CI Various - Distribution Routines - D055 - Planned Replacement of Deteriorated Equipment
(ATO) (NSEB M12898)
NSPI Responses to NSEB Information Requests

Request IR-1:

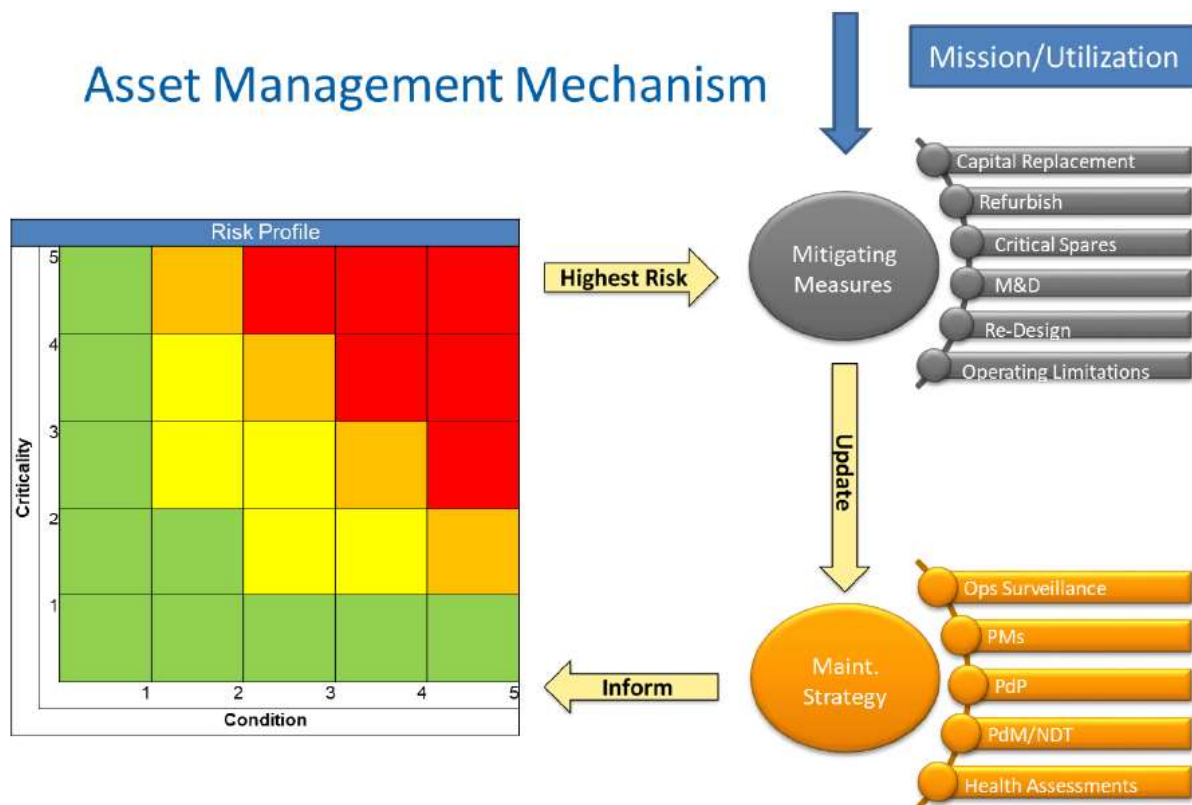
Please describe how the ability to mitigate each asset is scored, the range of scores applied to the risk rating, what each score means, and how asset condition is weighted in the criticality score.

NS Power does not understand what the “ability to mitigate each asset” in this IR is referring to. No such factor exists in the Company’s condition or criticality scoring for feeder risks. In NS Power’s asset management mechanism shown below, risk mitigation measures follow from risk identification; it is not a factor of the risk itself.
